Roads and Maritime Reference: SYD17/01766/02 (A25080397)  
Council Ref: 1/2018/PLP

**PLANNING PROPOSAL – ADDITIONAL PERMITTED USE TO ALLOW FOR EDUCATIONAL ESTABLISHMENT (SCHOOL) AT 2 PERCY STREET, AUBURN**

## TAB B:

# TAB C

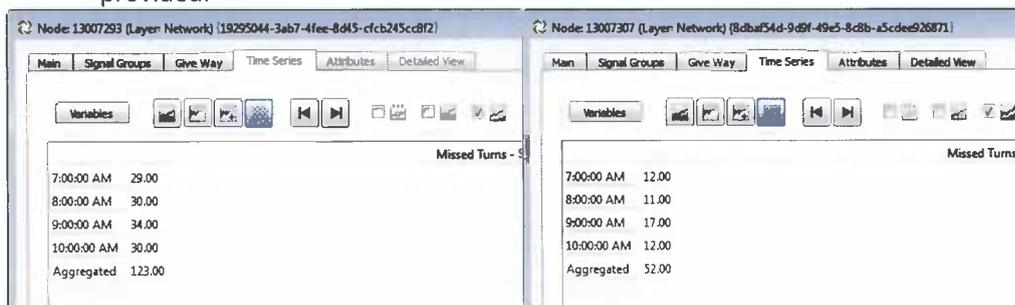
- Same capacity was used although there is different number of lane in the section near St Hilliers Rd / Rawson St intersection. It is recommended to review or justification should be provided.

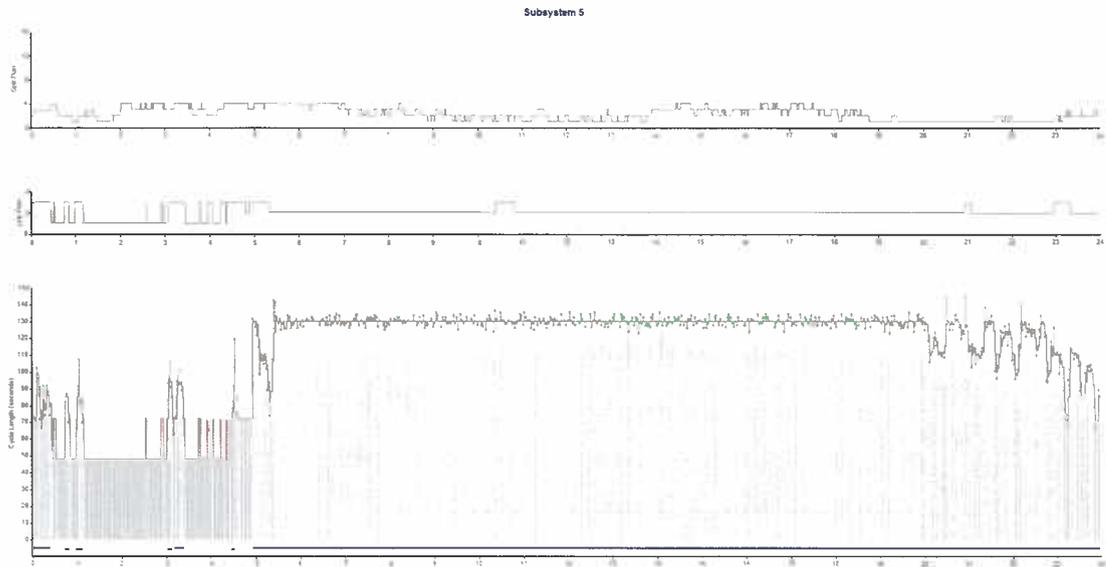
- Relatively high number of missed turn at St Hilliers Rd / Rawson St and Station Rd / Rawson St intersections in both AM and PM models. Parameters such as look ahead distance should be reviewed to reduce the number of missed turn vehicles or justification should be provided.

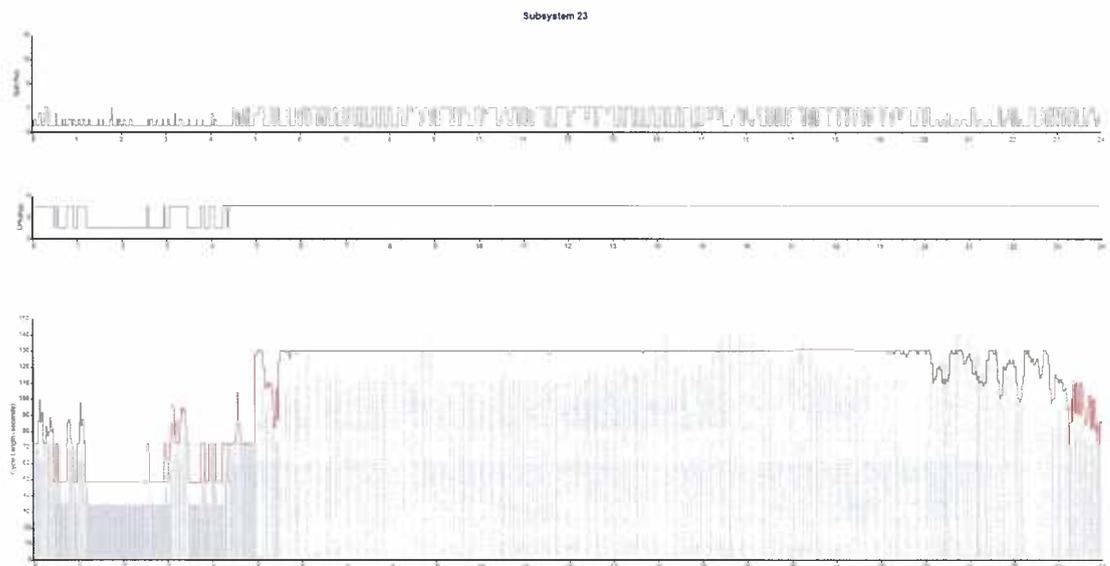
- According to SCATS, St Hilliers intersection was running 130 seconds cycle time in both AM and PM peaks. However it were modelled as 115 secs and 120 seconds in AM and PM respectively. It is recommended to review the cycle time and reflect the existing traffic condition at site.

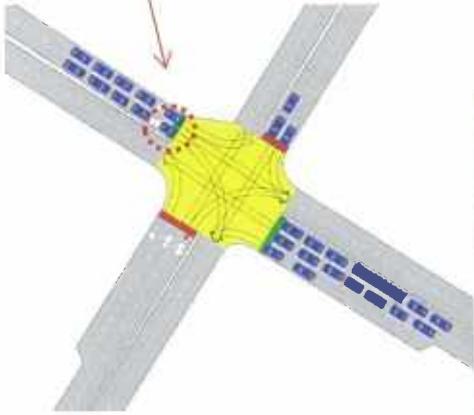
- Filter right turn in phase A were allowed into future models which could be a safety concern. It is not allowed in the existing signal setting. It should be reviewed.

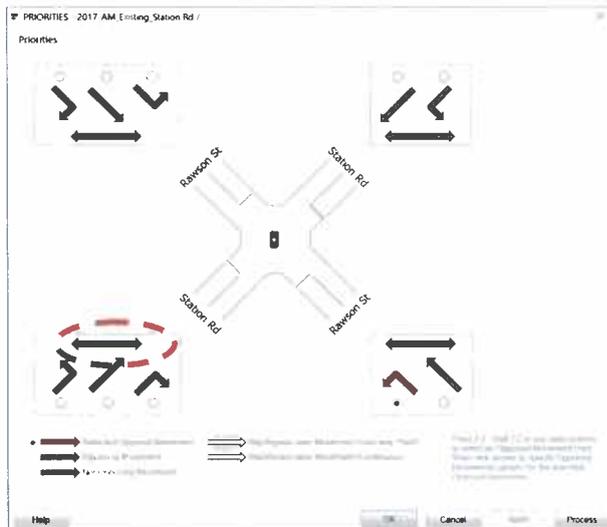
60mins peak flow period were used for all models (both traffic and pedestrian) where the 30 minutes default values should be used, otherwise, intersection performance could be underestimated because of possible oversaturation during the peak period which will not be accounted for when flows are averaged over a long period.

***Rawson Street / St Hilliers Road Intersection -***

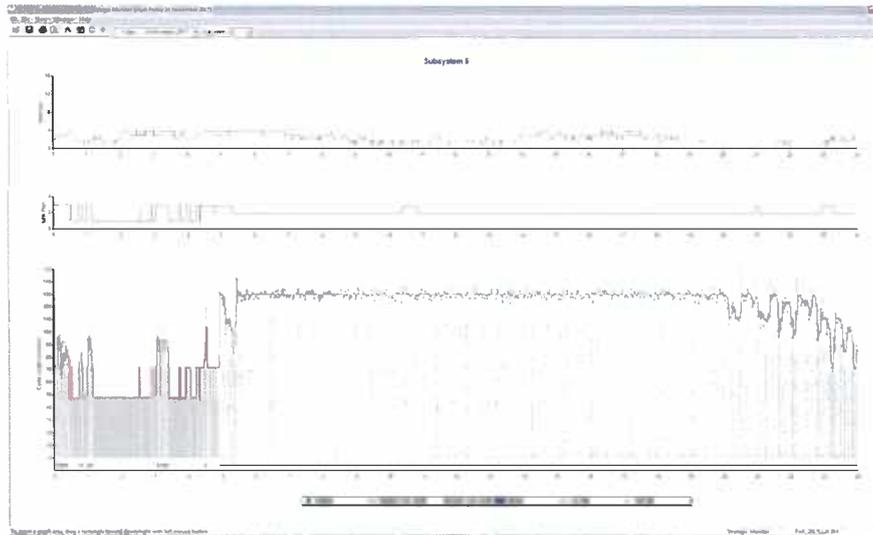
Cycle time for existing AM and PM peaks are different to SCATS setting which running at 130secs. Different cycle time may be used in future scenarios according to different traffic pattern. Justification should be provided to how the proposed setting to work with other intersection in the corridor for future scenarios.

***Rawson Street / Station Road Road Intersection -***

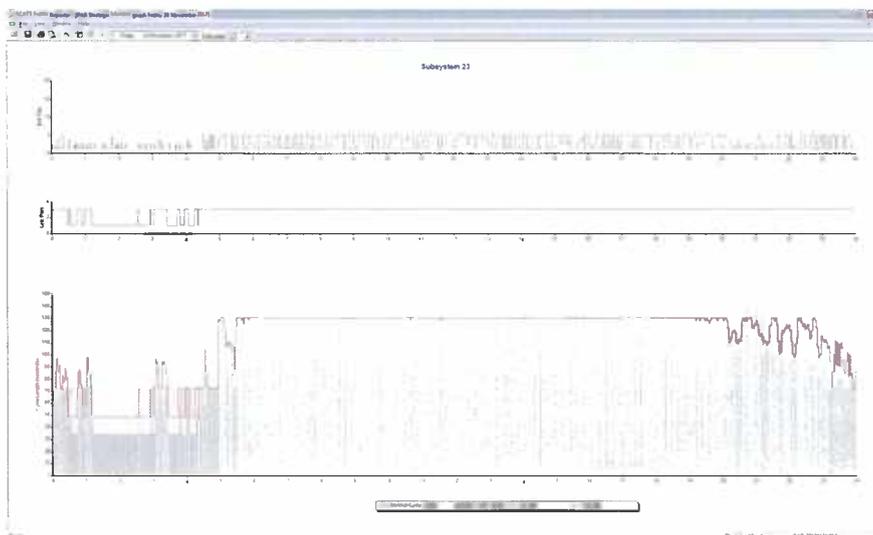
Cycle time for existing AM and PM peaks are different to SCATS setting which running at 130secs. Different cycle time may be used in future scenarios according to different traffic pattern. Justification should be provided to how the proposed setting to work with other intersection in the corridor for future scenarios.
